YAKUTAT AIRPORT RUNWAY & TAXIWAY LIGHTING IMPROVEMENTS

A.I.P. NO. 3-02-0327-13-99
PROJECT NO. 67522

"AS-BUILTS"

RUNWAY 2-20 LIGHTING PLAN
TAXIWAYS "B", "C" & "D"/APRON "B"

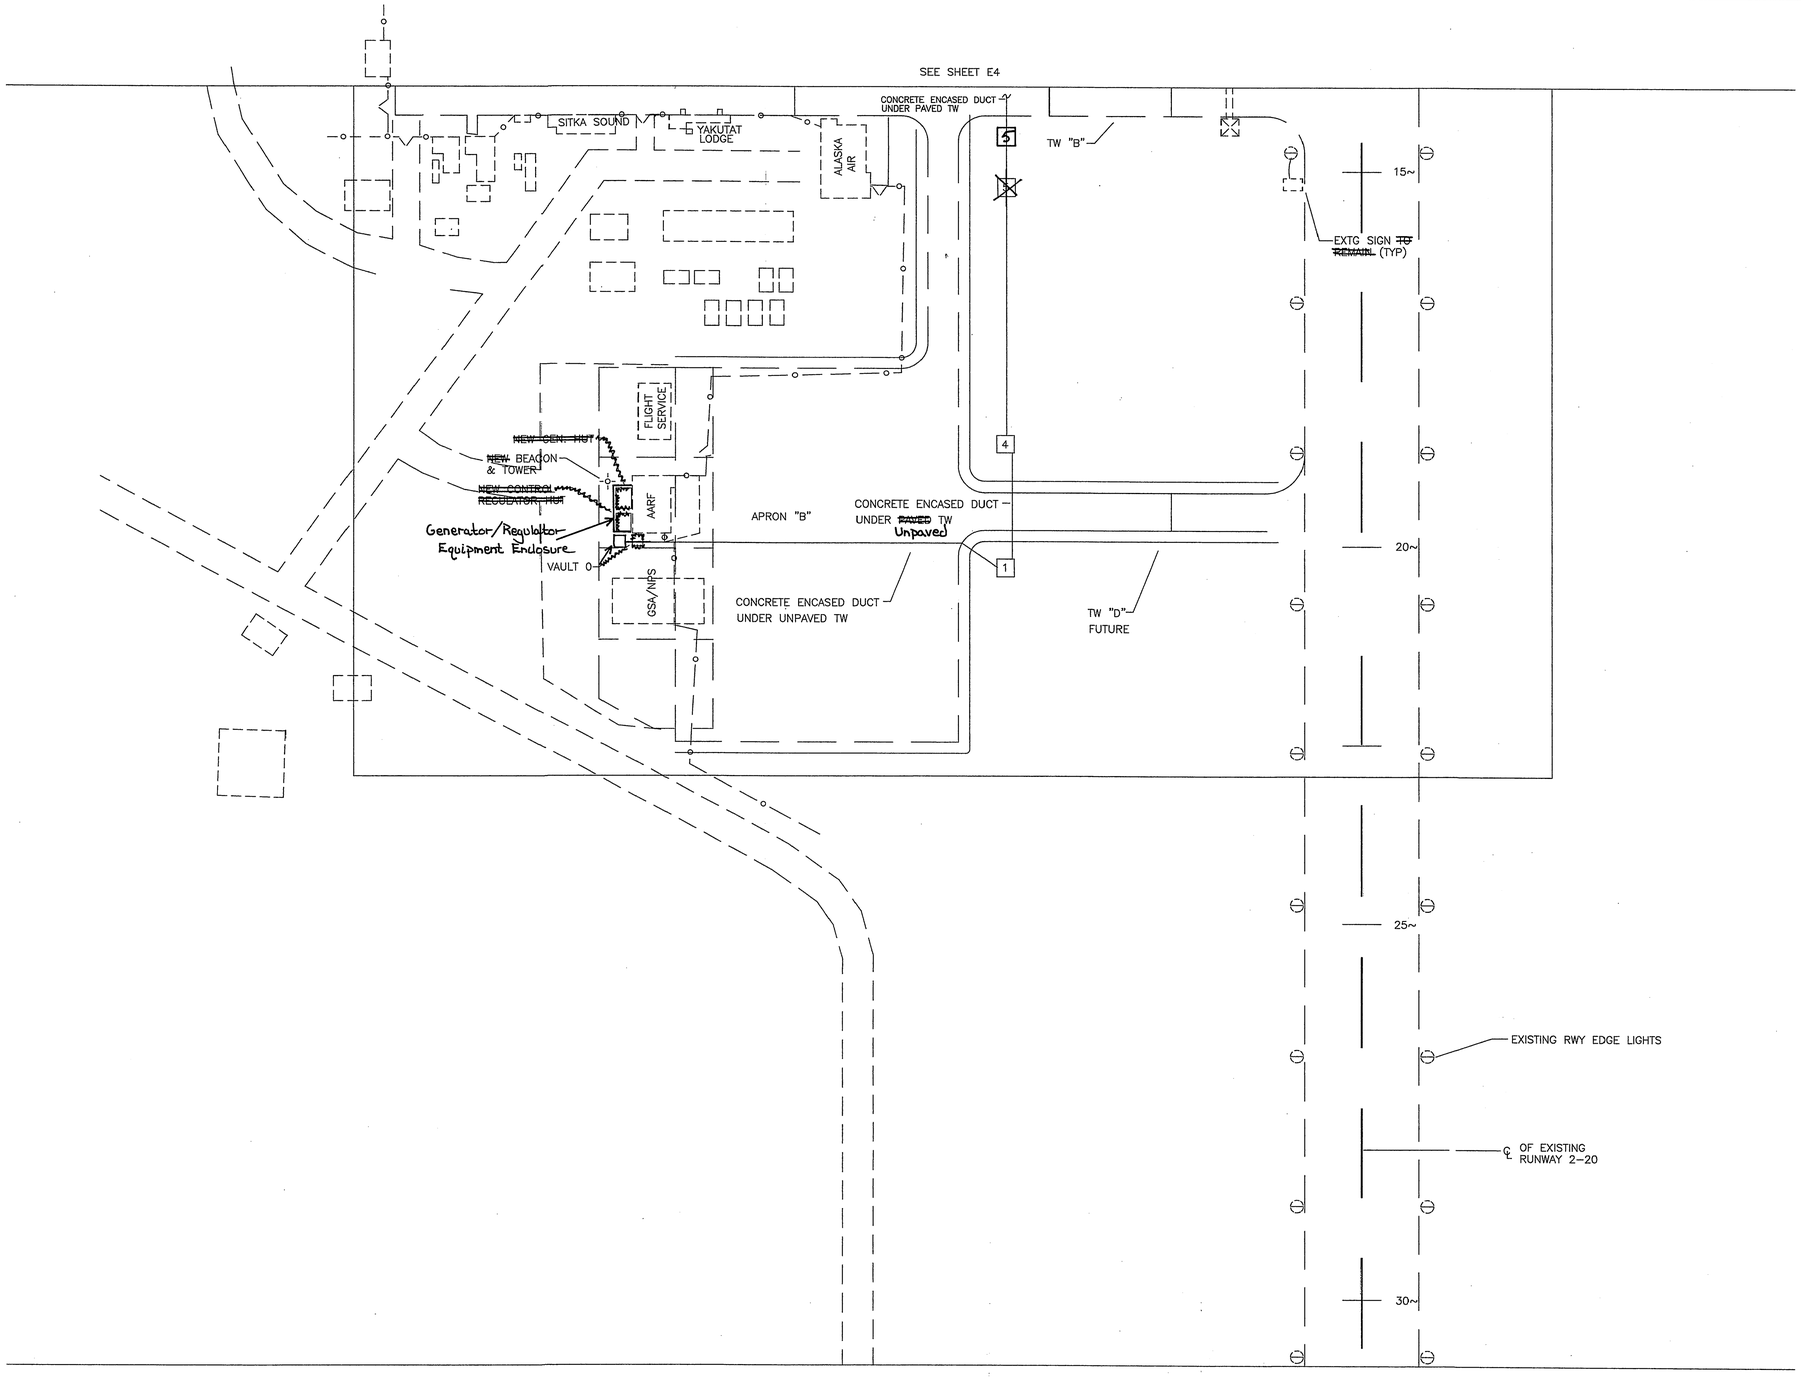
PATH:	P:\YAK\72214\ENIE3.DWG	
PLOT:	P:\-LIB\-PLOT\PLOTF.PCP(100) OR PLOTH.PCP(200)	
BY:	DATE:	DESCRIPTION OF CHANGE:
RBS	2/15/00	SHOW CONCRETE PAVEMENT PATCHES

RUNWAYS 11-29 & 2-20 LIGHTING PLAN TAXIWAY "A" & APRON "A"

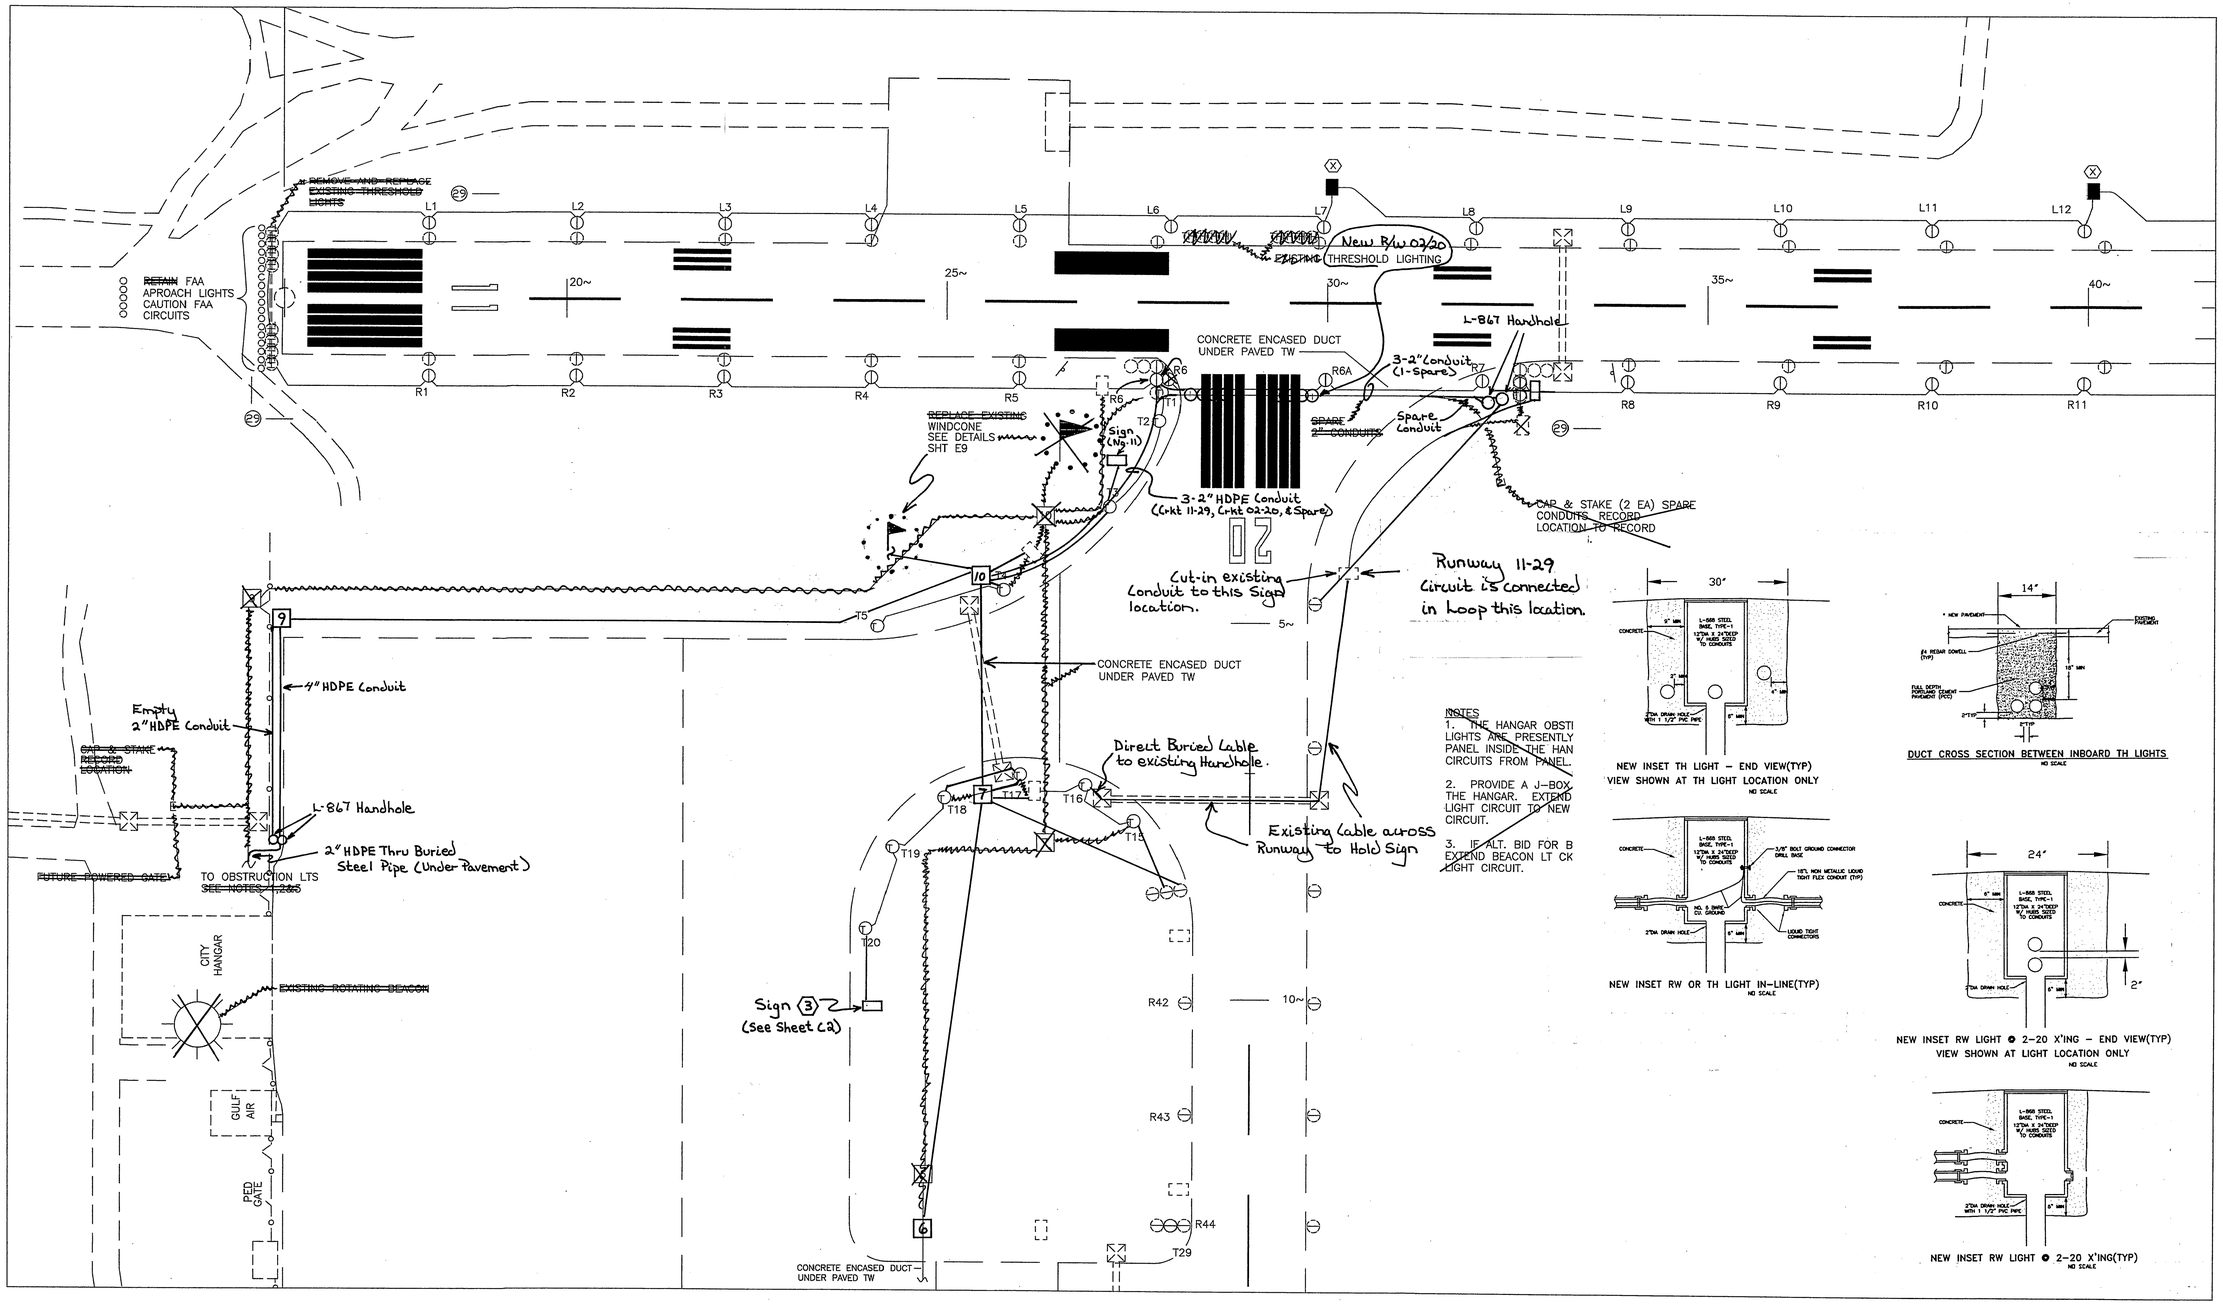
PATH:	P:\YAK\72214\EN\E4.DWG	
PLOT:	P:\-LIB\-PLOT\PLOTF.PCP(100) OR PLOTH.PCP(200)	
BY:	DATE:	DESCRIPTION OF CHANGE:
RBS	2/15/00	SHOW CONCRETE PAVEMENT PATCHES

RUNWAY 11-29 LIGHTING PLAN

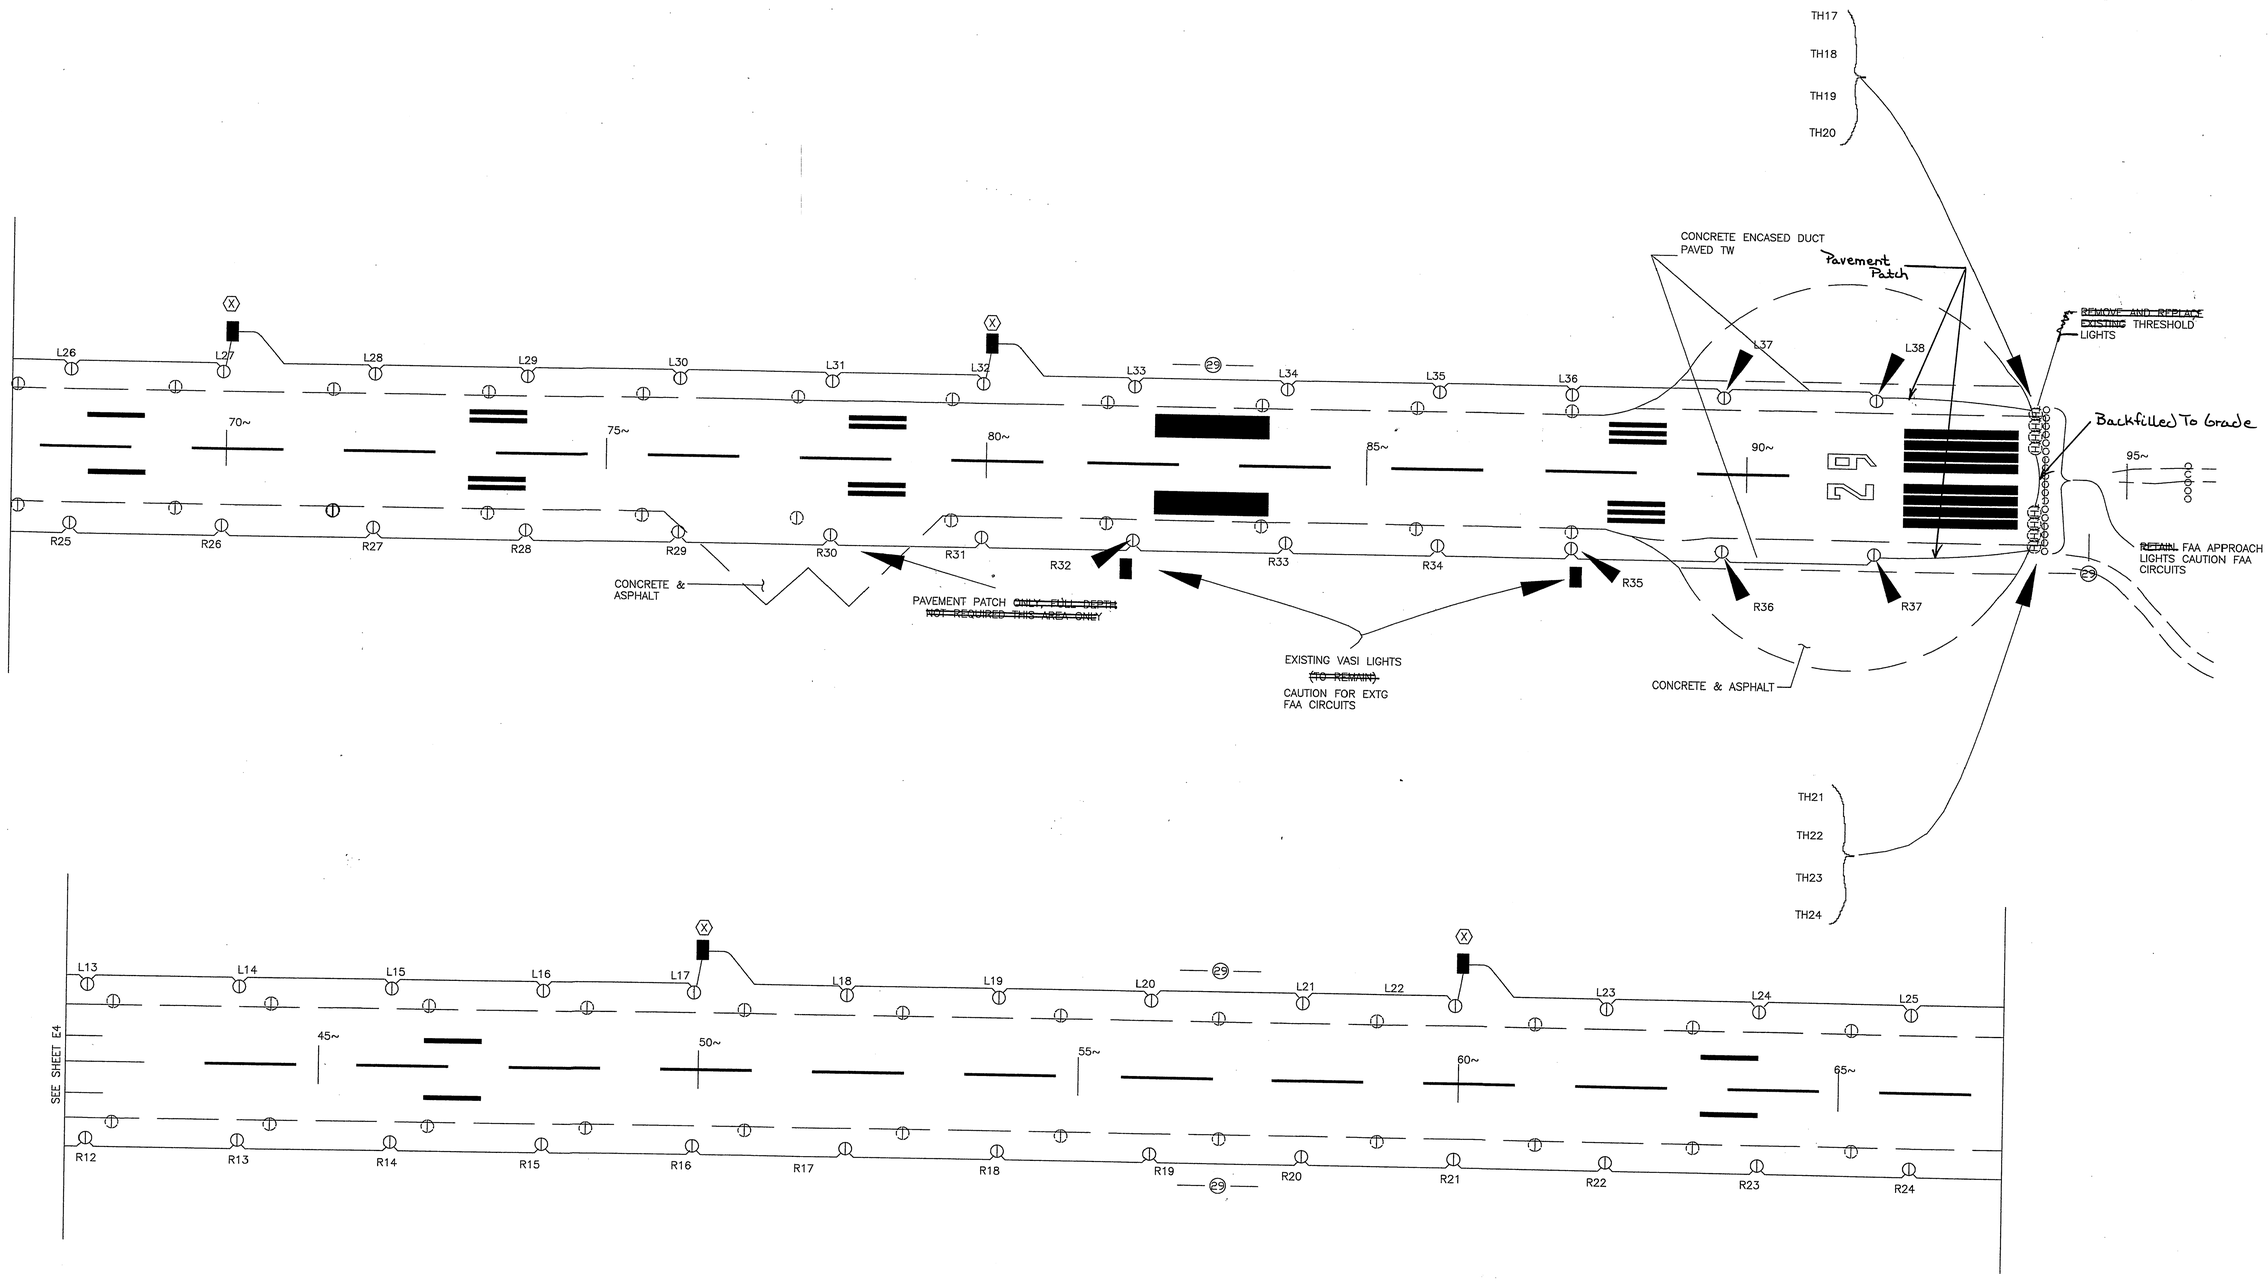
PATH:	P:\YAK\72214\ENIE5.DWG	
PLOT:	P:\-LIB\-PLOT\PLOTF.PCP(100) OR PLOTH.PCP(200)	
BY:	DATE:	DESCRIPTION OF CHANGE:
RBS	2/15/00	SHOW CONCRETE PAVEMENT PATCH

BELOW UNPAVED TAXIWAYS

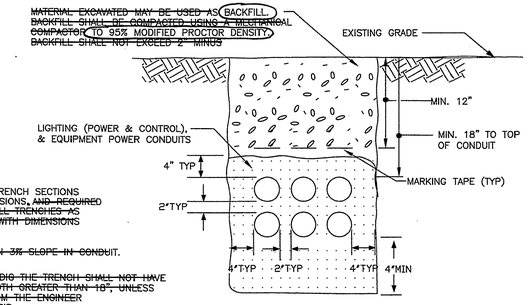
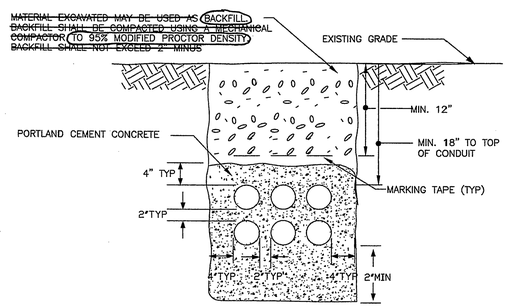
~~MATERIAL EXCAVATED MAY BE USED AS~~ BACKFILL. ~~BACKFILL SHALL BE COMPACTED USING A MECHANICAL COMPACTOR~~ TO 95% MODIFIED PROCTOR DENSITY. ~~BACKFILL SHALL NOT EXCEED 2" MINUS~~

NOTES:
1. THESE ARE TYPICAL TRENCH SECTIONS SHOWING MINIMUM DIMENSIONS. ~~AND REQUIRED MATERIALS. CONFIGURE ALL TRENCHES AS NECESSARY TO COMPLY WITH DIMENSIONS SHOWN.~~

~~2. ALLOW NO MORE THAN 3% SLOPE IN CONDUIT.~~

~~3. EQUIPMENT USED TO DIG THE TRENCH SHALL NOT HAVE A BUCKET OR BLADE WIDTH GREATER THAN 18", UNLESS ALLOWED IN WRITING FROM THE ENGINEER ON A CASE BY CASE BASIS.~~

~~MATERIAL EXCAVATED MAY BE USED AS~~ BACKFILL. ~~BACKFILL SHALL BE COMPACTED USING A MECHANICAL COMPACTOR~~ TO 95% MODIFIED PROCTOR DENSITY. ~~BACKFILL SHALL NOT EXCEED 2" MINUS~~

TYPE 1, 2, 3 & 4 VAULT (TYP)

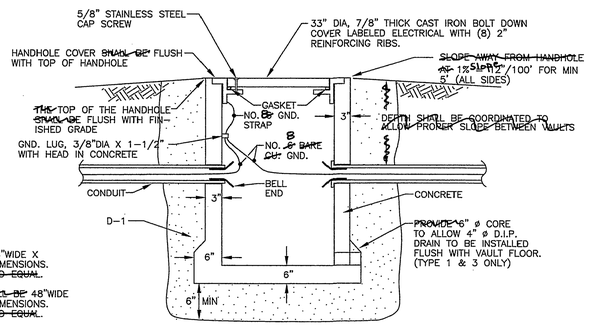
NOTE:
1. TYPE 1 HANDHOLE: ~~SHALL BE~~ 48"WIDE X 48"LONG X 48"DEEP OUTSIDE DIMENSIONS. UTILIVAULT 444-LA ~~OR APPROVED EQUAL~~.
2. TYPE 3 AND 4 HANDHOLES: ~~SHALL BE~~ 48"WIDE 48"LONG X 36"DEEP OUTSIDE DIMENSIONS. UTILIVAULT 443-LA ~~OR APPROVED EQUAL~~.
3. ~~THE~~ COVERS FOR HAND HOLES ~~SHALL BE~~ LABLELED "ELECTRICAL".

BELOW PAVED TAXIWAYS & RUNWAYS

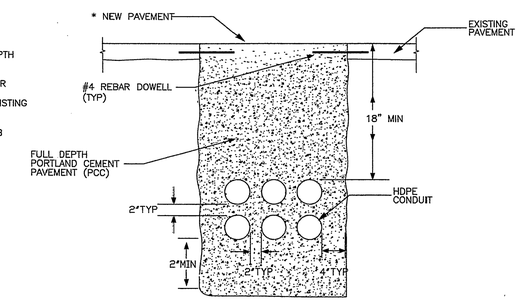
* NOTE:
1. NEW PAVEMENT PATCH MATERIAL ~~SHALL BE~~ PORTLAND CEMENT (PCC) PAVEMENT. CONCRETE ~~SHALL BE~~ FULL DEPTH
2. FOR PORTLAND CEMENT CONCRETE (PCC) PAVEMENTS: ~~PROVIDE~~ NO 4 REBAR DIAMETER BY 1'-2" LONG DOWELS (0'-7" PENETRATION INTO EXISTING PCC PAVEMENT-BOTH SIDES STAGGERED) 18" ON CENTERS, ~~EVASE~~ AT MID HEIGHT OF SLAB DEPTH. GREASED DRILLED HOLE HALF OF DOWEL LENGTH. ~~AND PLACE IN HOLE.~~

WINDCONE FOUNDATIONS

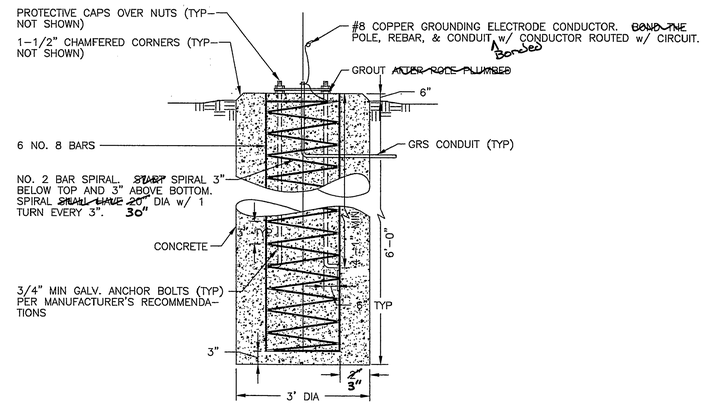
1. BACKFILL: ~~3/4"~~ N.F.S. SAND & GRAVEL COMPACTED TO 95% MODIFIED PROCTOR DENSITY.
2. ANCHOR BOLTS: ~~TO MEET~~ ATSM–A36 w/ MINIMUM YIELD STRESS OF 36.0 KSI.

ROTATING BEACON & BEACON POLE DETAIL

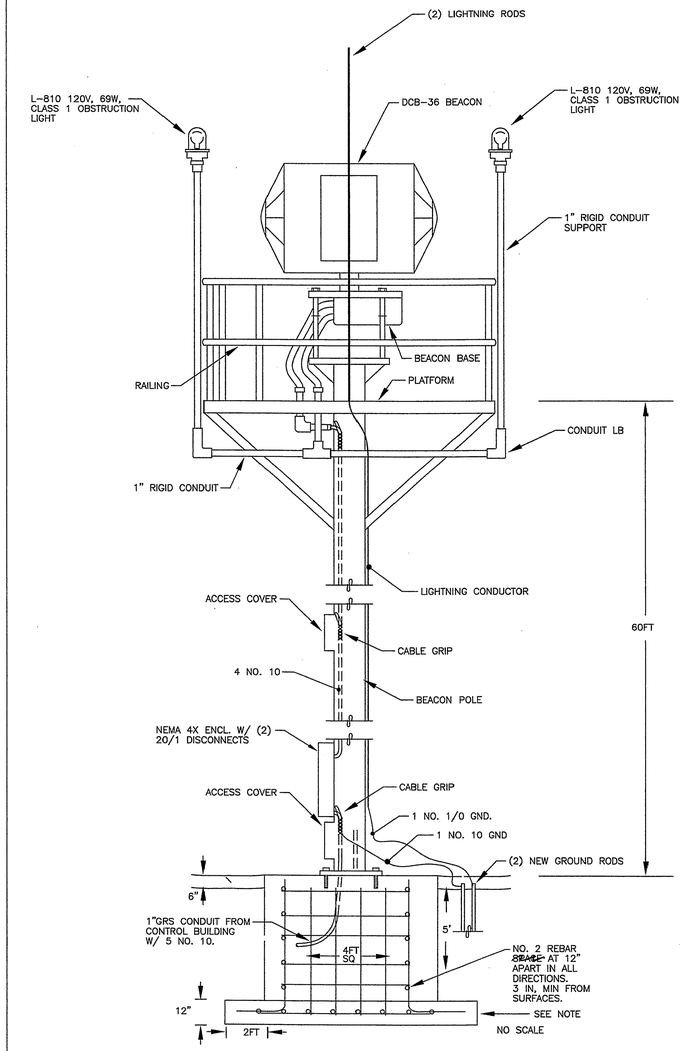
NOTE: MINIMUM FOUNDATION SHOWN.
FOUNDATION ~~SHALL~~ SUPPORT STRUCTURE
FOR 100MPH CONTINUOUS WINDS, MIN.
~~COORDINATE W/ STRUCTURE MANUFACTURER.~~

PIPING DIAGRAM – FUEL SYATEM

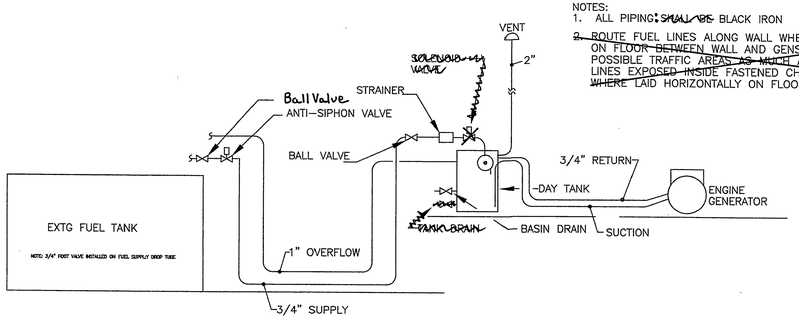
NOTES:
1. ALL PIPING: ~~SHALL BE~~ BLACK IRON
2. ~~ROUTE~~ FUEL LINES ALONG WALL WHERE POSSIBLE. ~~ROUTE ON FLOOR BETWEEN~~ WALL AND GENSET ~~ENGINE~~ AVOID POSSIBLE TRAFFIC ~~AREAS AS MUCH~~ AS POSSIBLE. INSTALL LINES ~~EXPOSED INSIDE~~ FASTENED CHANNEL ~~ERECTOR WHERE~~ LAID HORIZONTALLY ON FLOOR.
